ADDENDUM NO. #1

RE: ITB# 016-20 – The Banks Bid Package #6 – Lot 23 Park, Lot 23/27 Garage Signage & Security

Addendum to the Construction Documents

LOT 23 STAIR AND ELEVATOR - LOWER LEVEL
PARTIAL PLAN
1
A250
1/4" = 1'-0"
NORTH

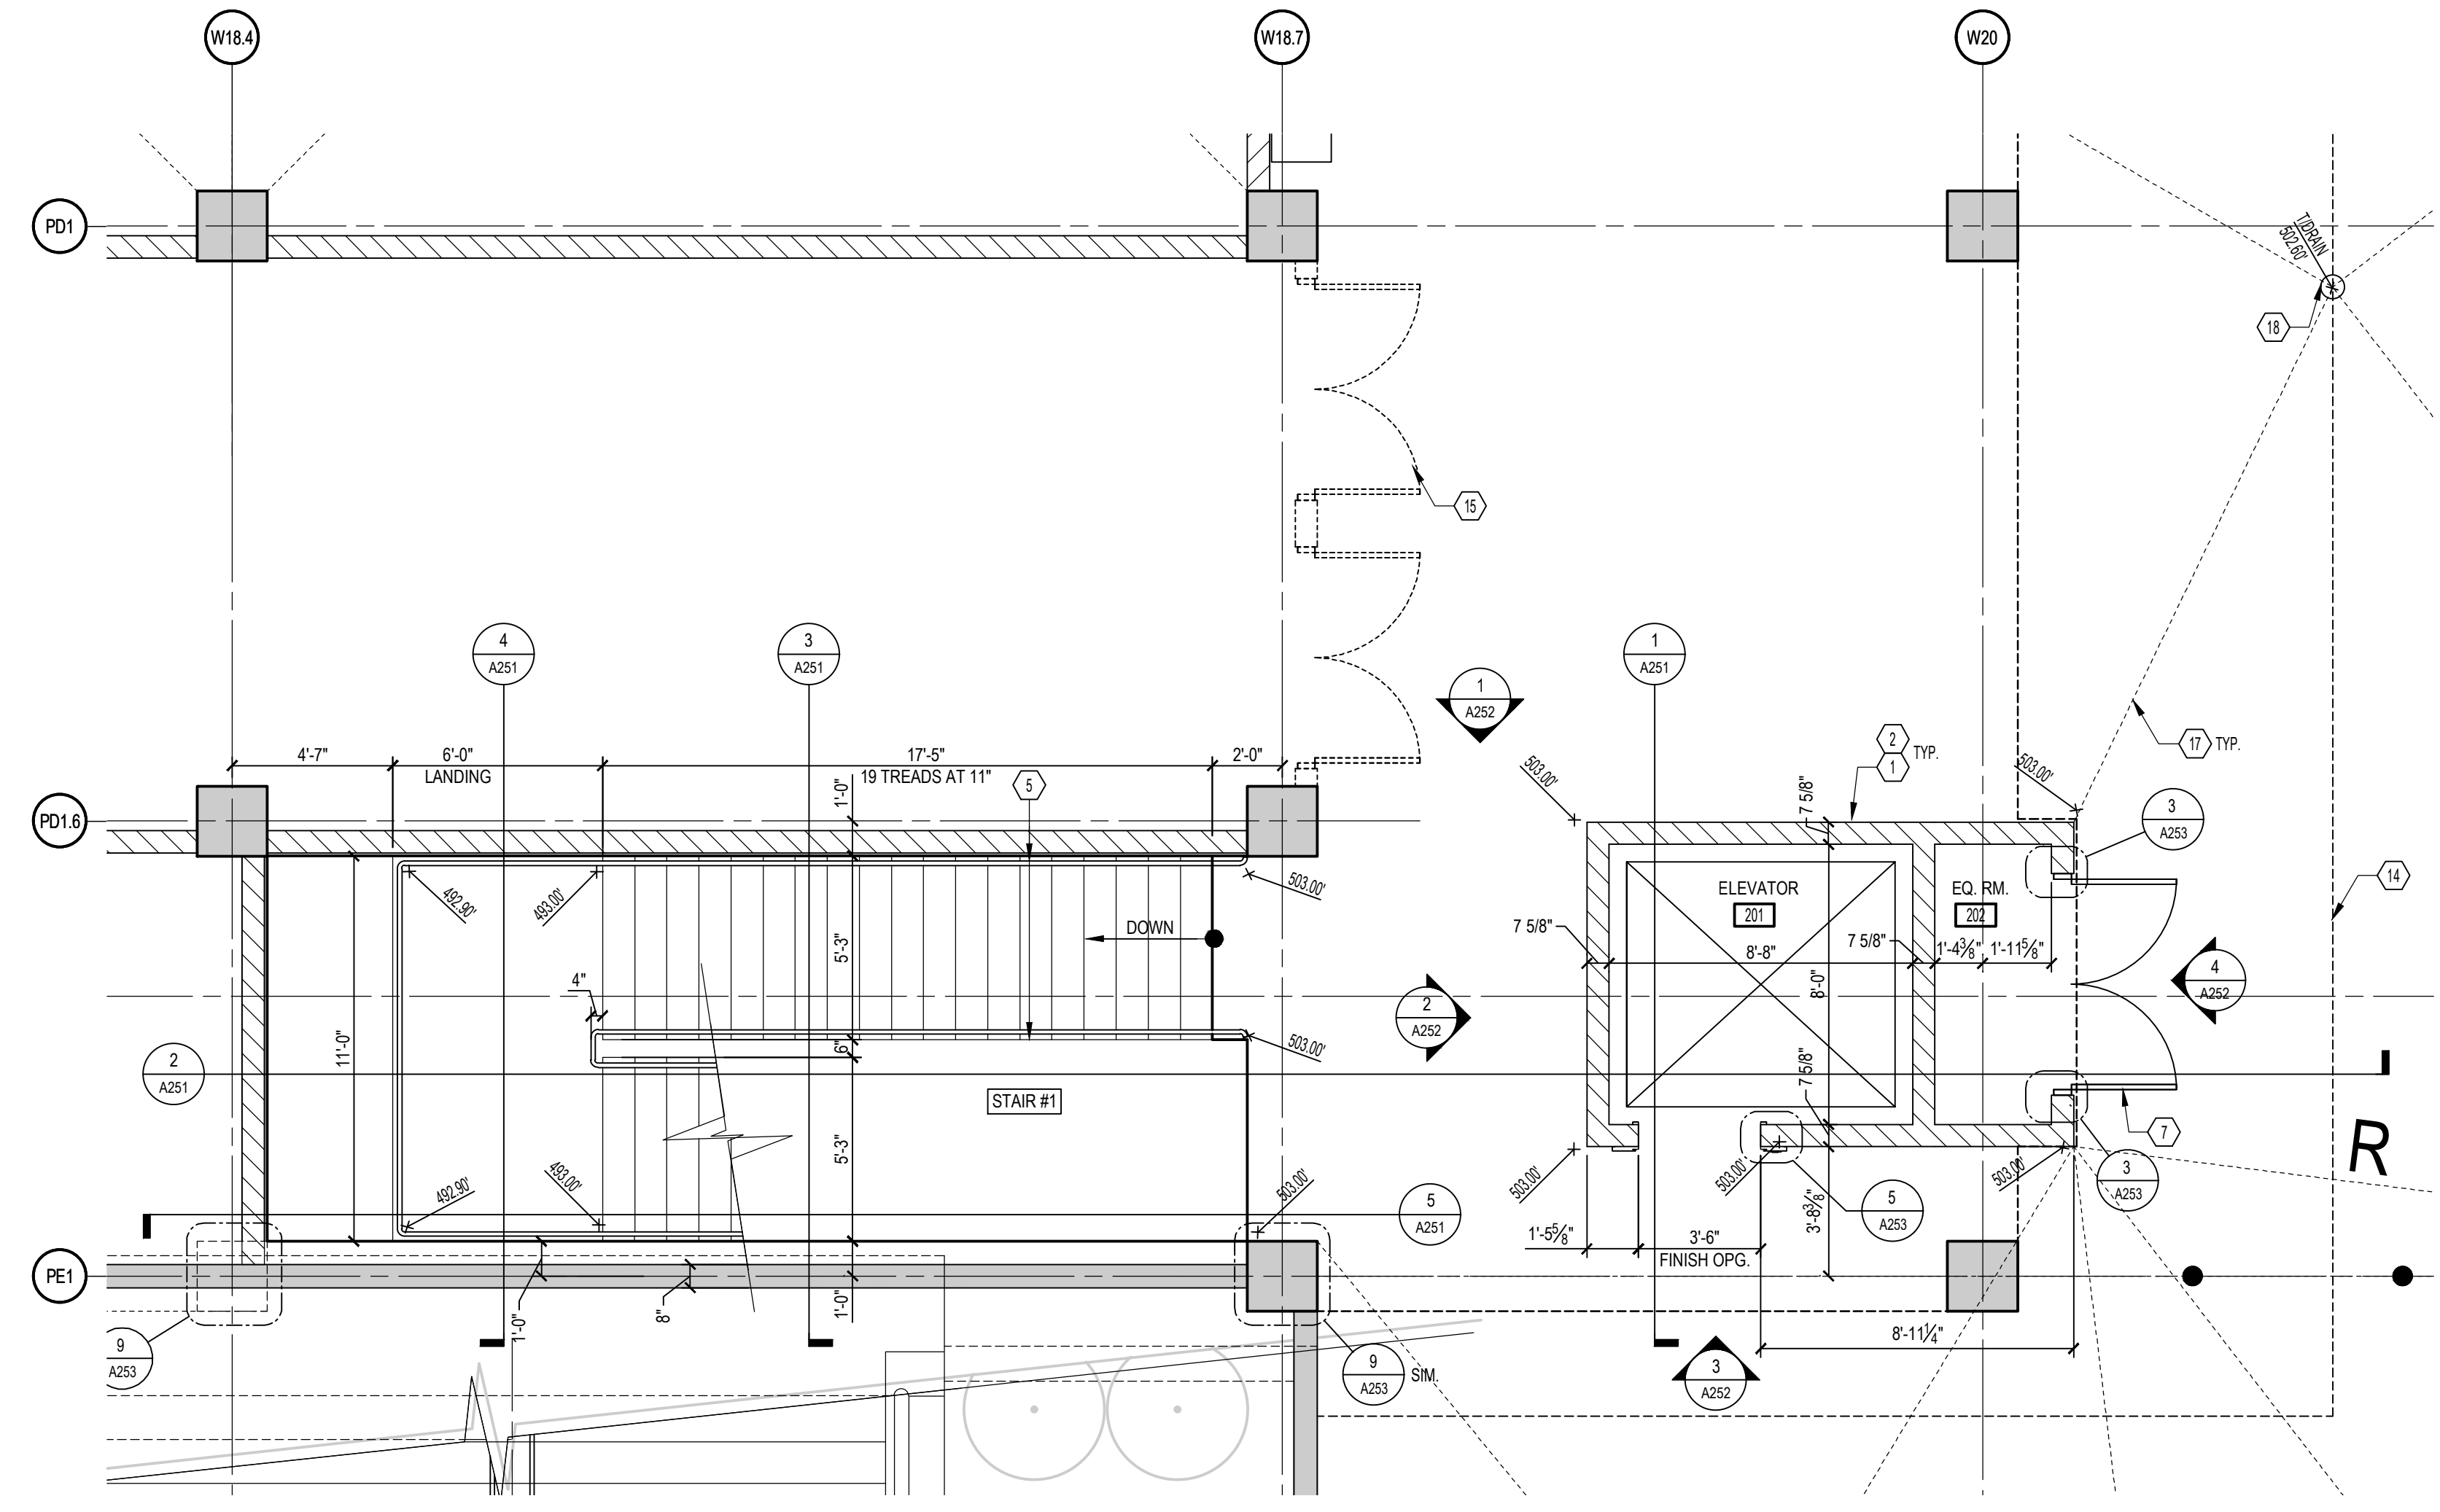
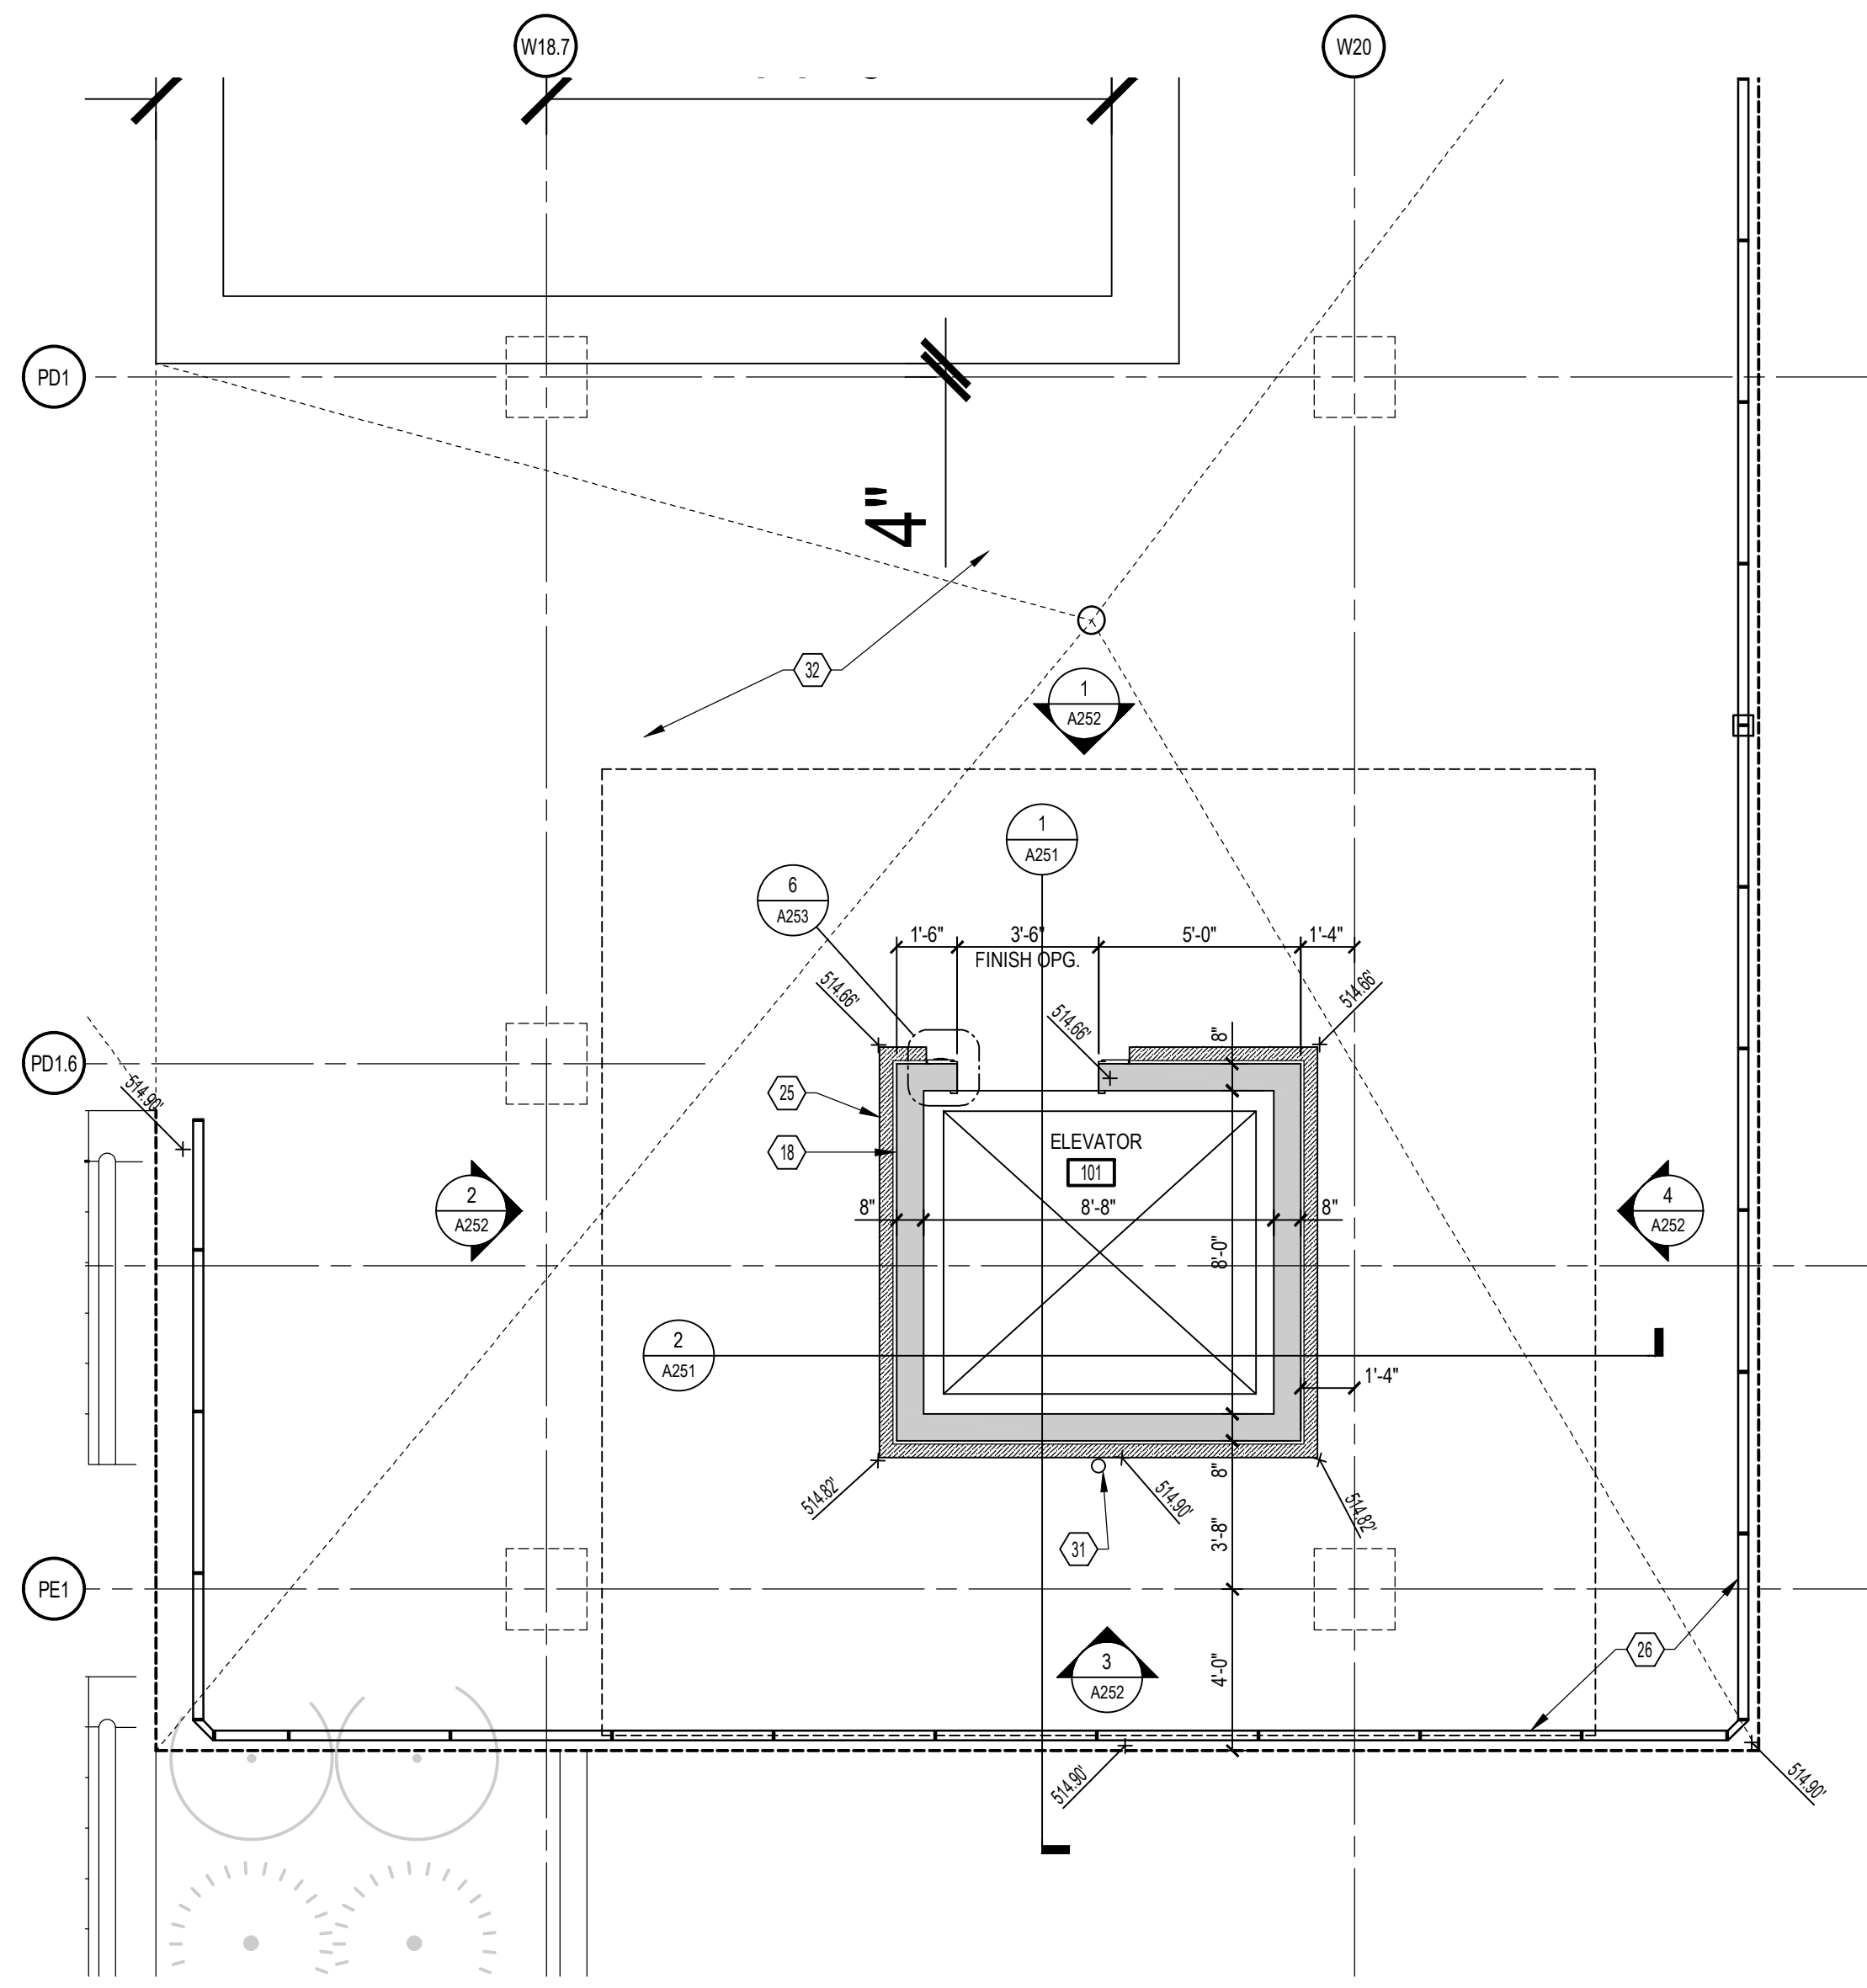
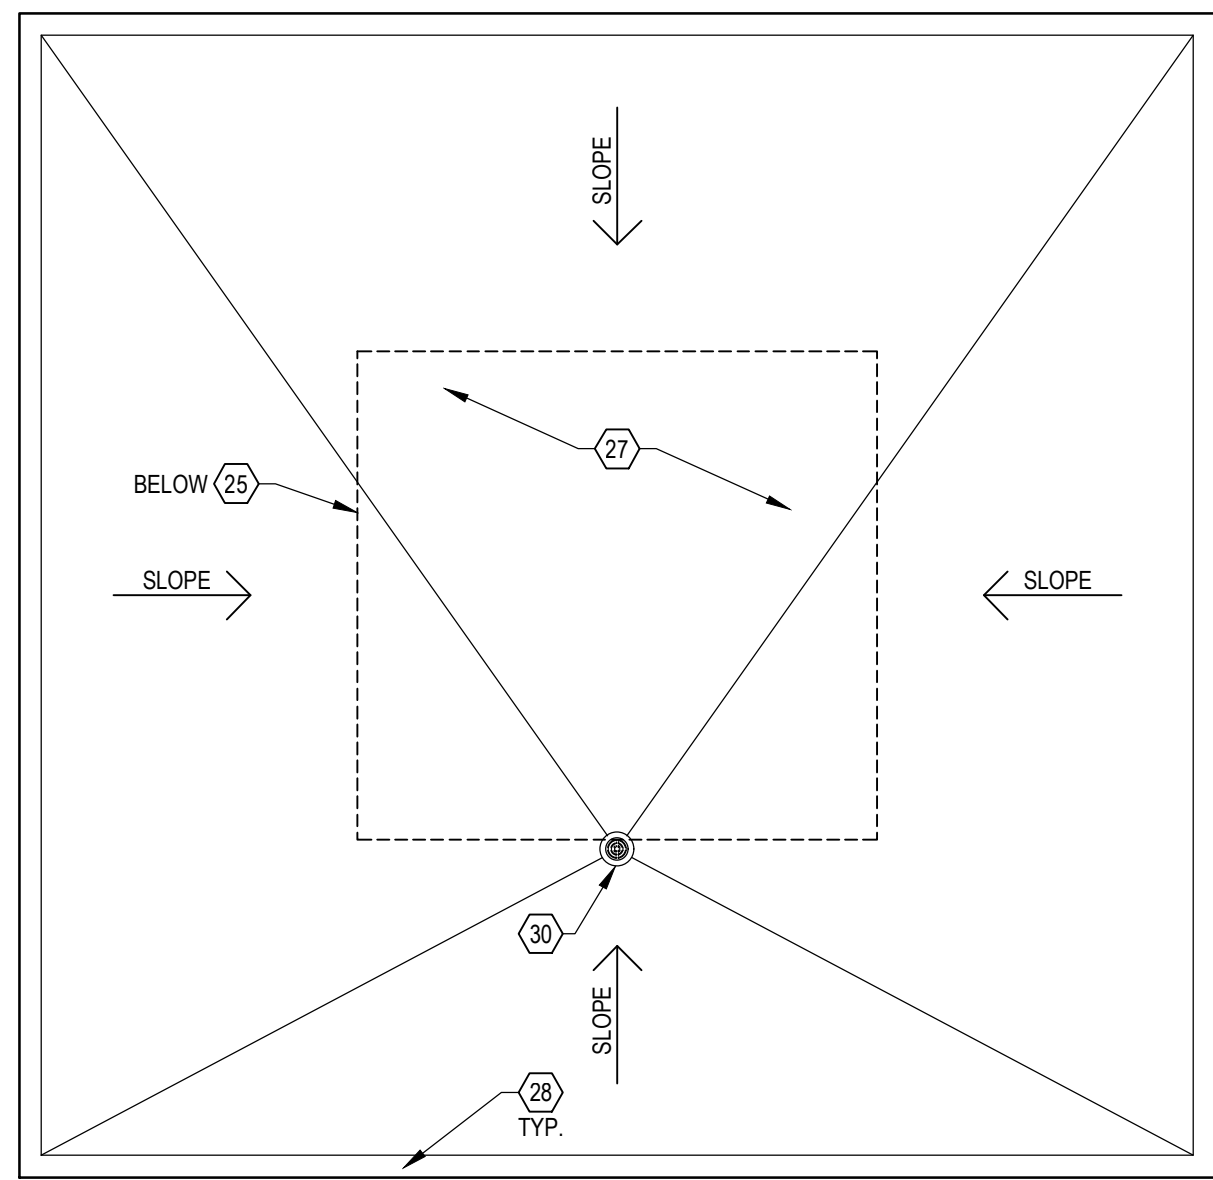
8. Drawing A250: (Drawing Reissued)

- Add Reflected Ceiling Plan.
